Addendum #1

Bid Opportunity: 7269-RW-22

Stewart Avenue Public School HVAC Upgrades

MECHANICAL ADDENDUM

M4.1

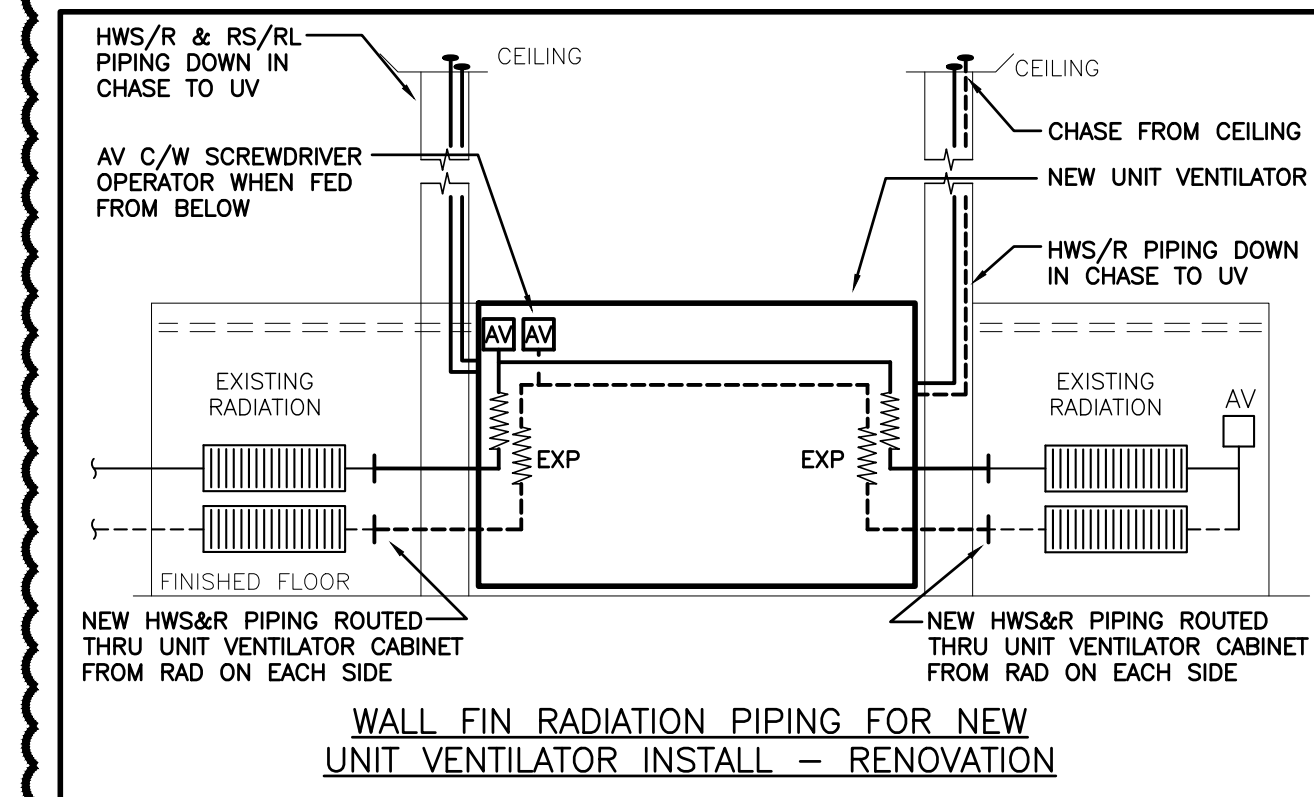
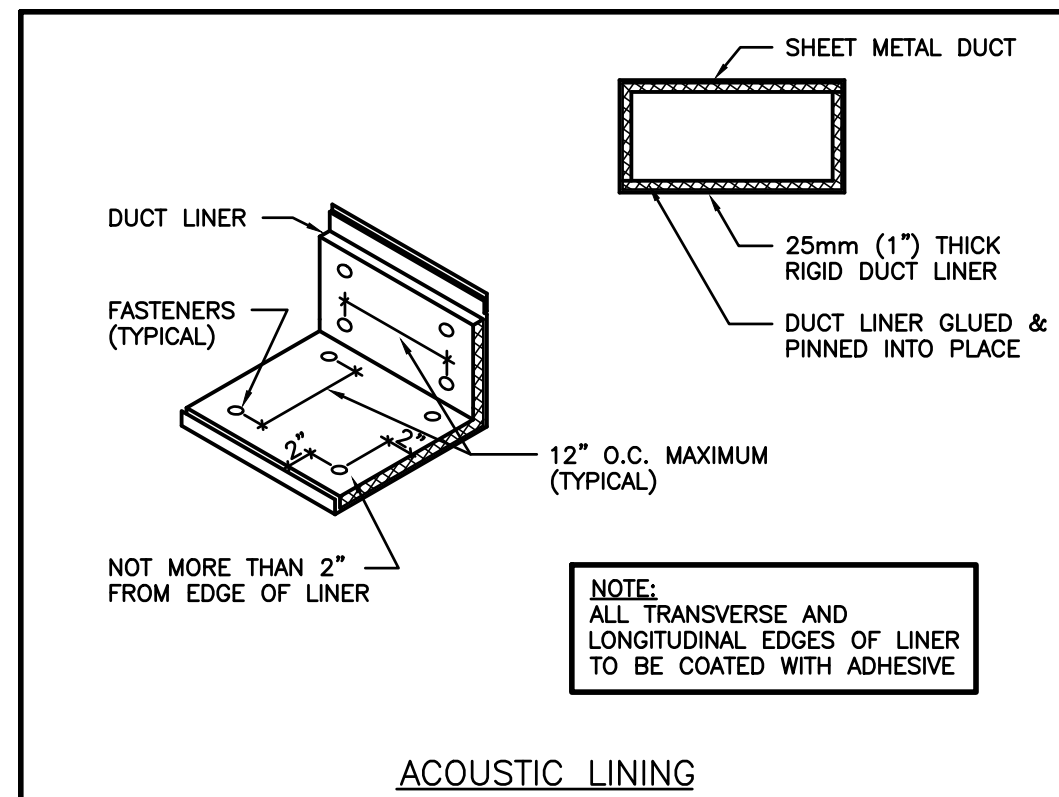
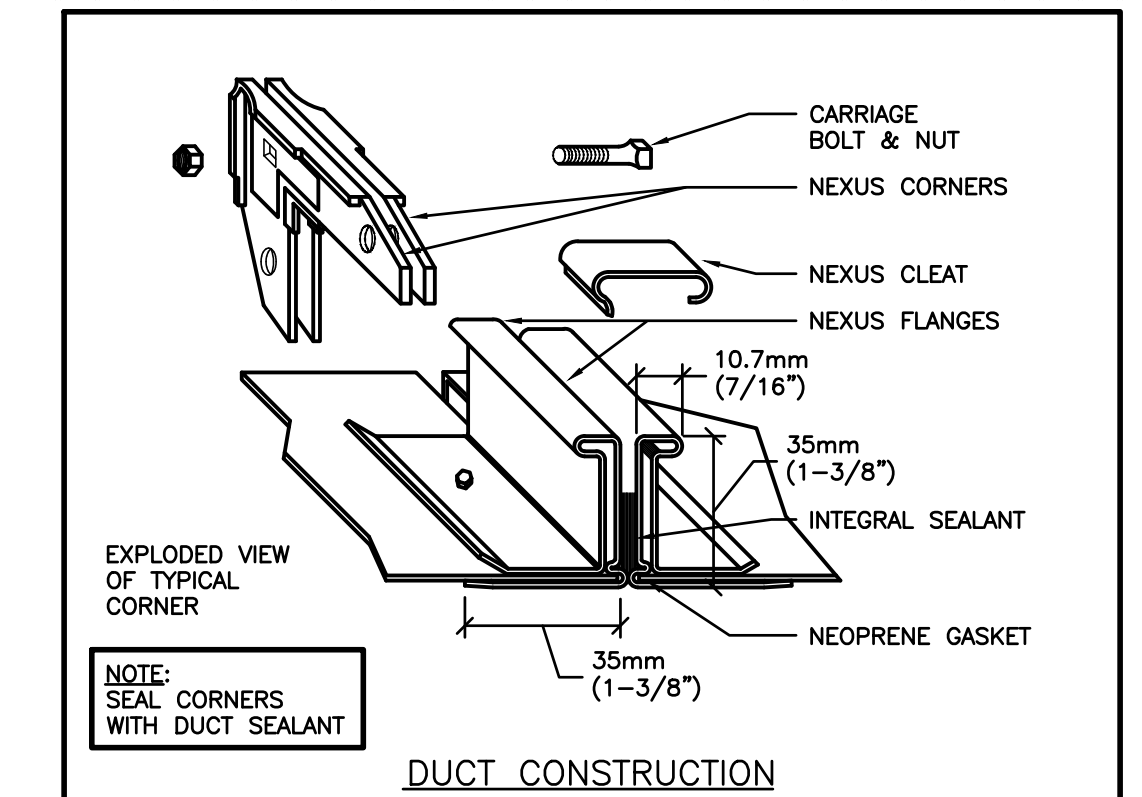
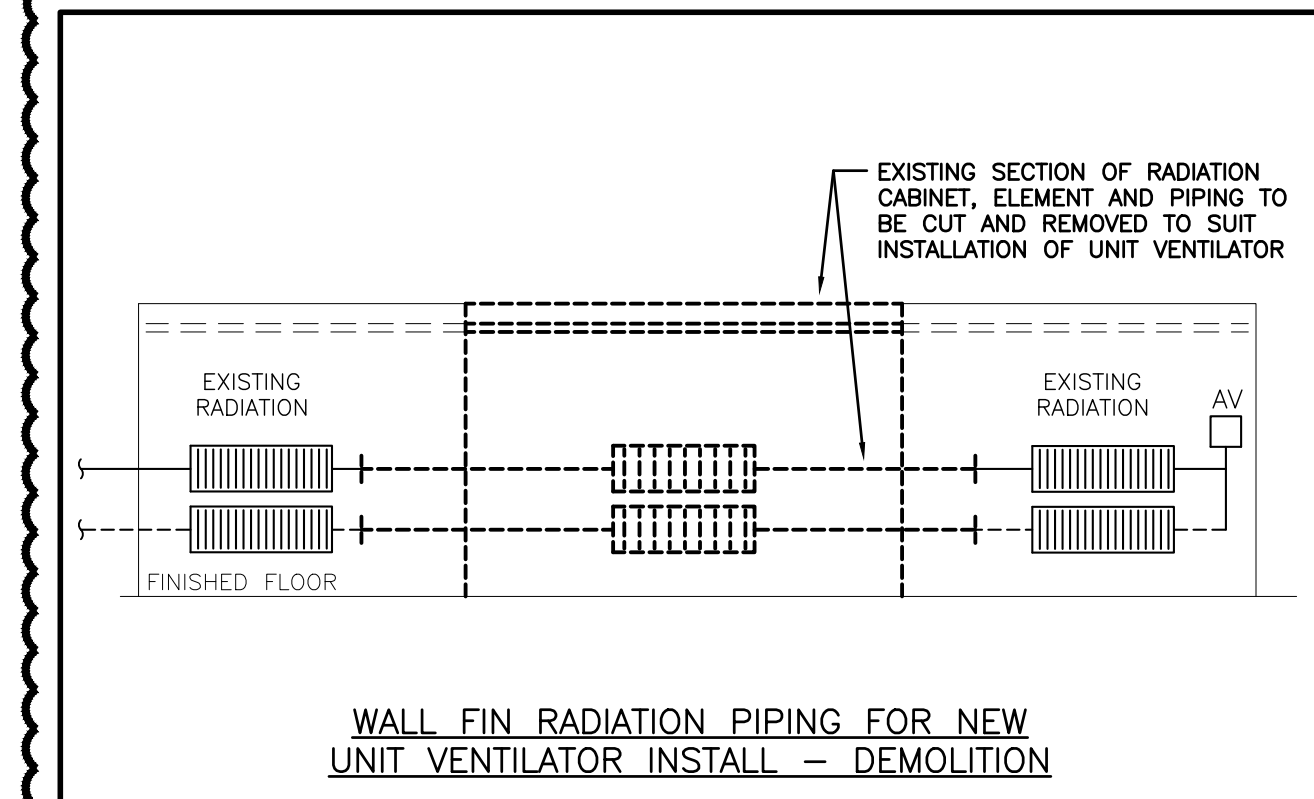
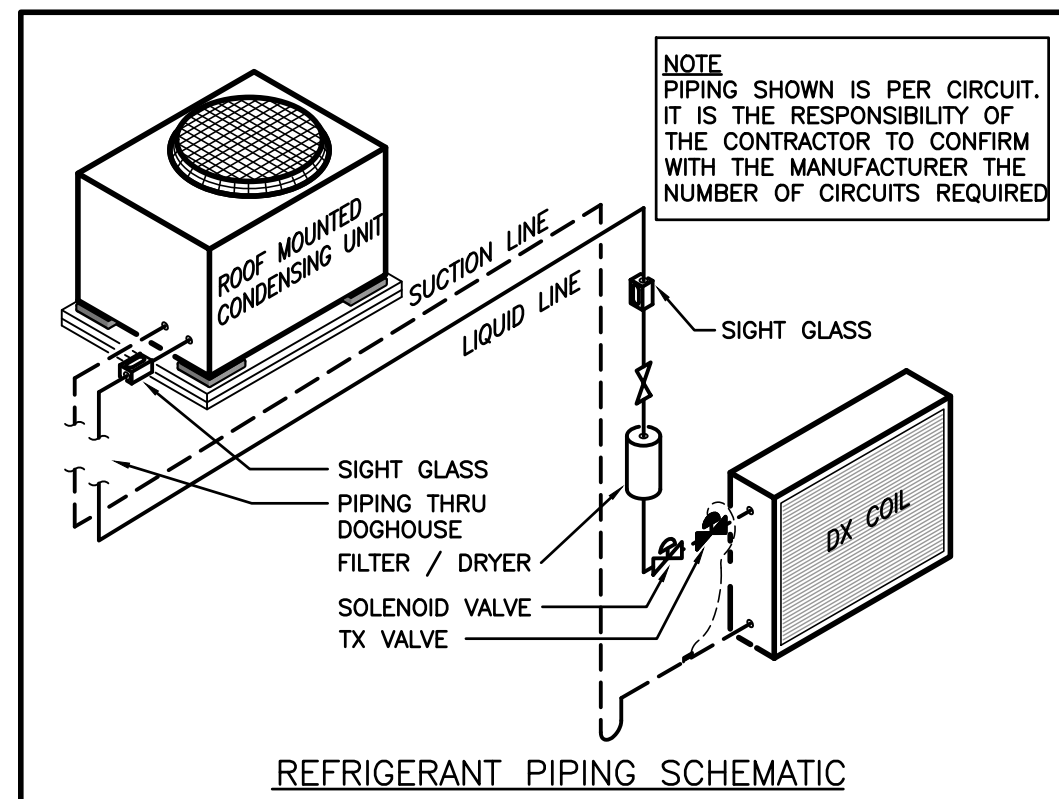
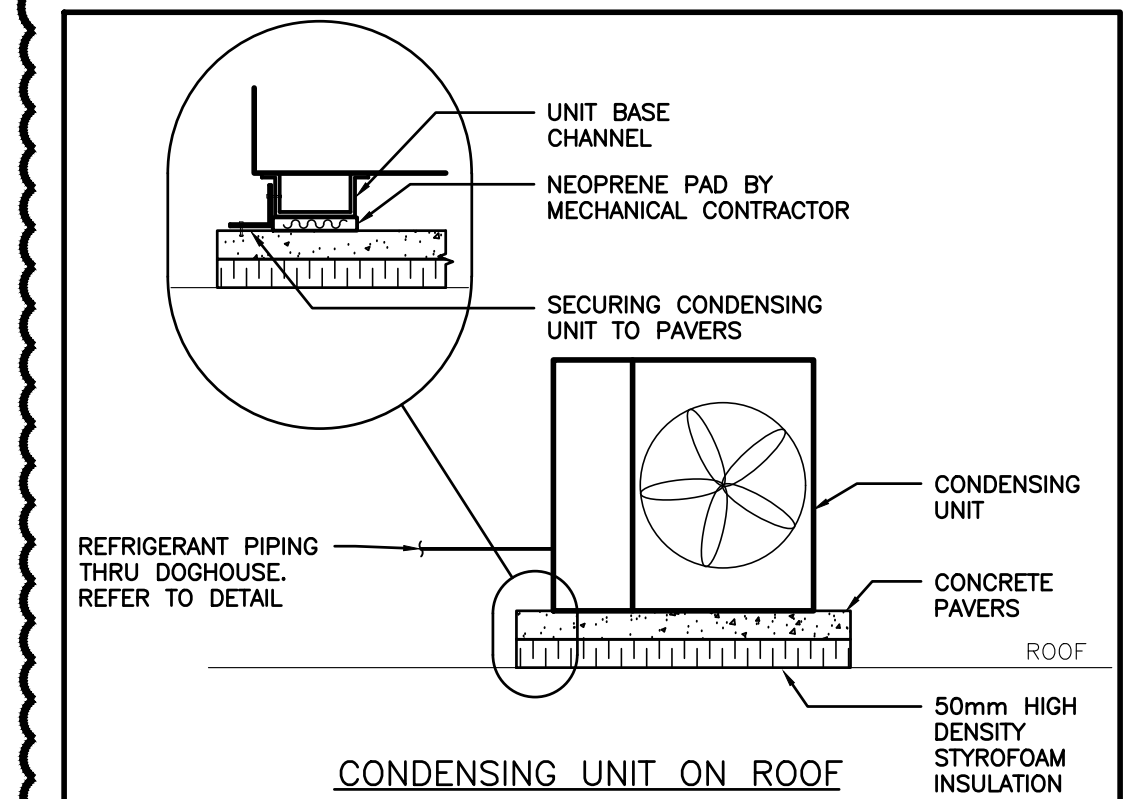
On the the detail drawing M4.1 there is a detail showing the expansion joints on the 1 1/4 piping around the new unit ventilators. Is this needed or required due to the the small offset around the new unit ventilators.

- 5.0 Reference Attached Re-Issued Drawing M4.1
.1 Refer to attached re-issued drawing M4.1 for revised ‘Wall Fin Radiation Piping for New Unit Ventilator Install- Demolition’, ‘Wall Fin Radiation Piping for New Unit Ventilator Install- Renovation’, ‘Pipe Routing to New Unit Ventilator’, and ‘Condensing Unit on Roof’ details.
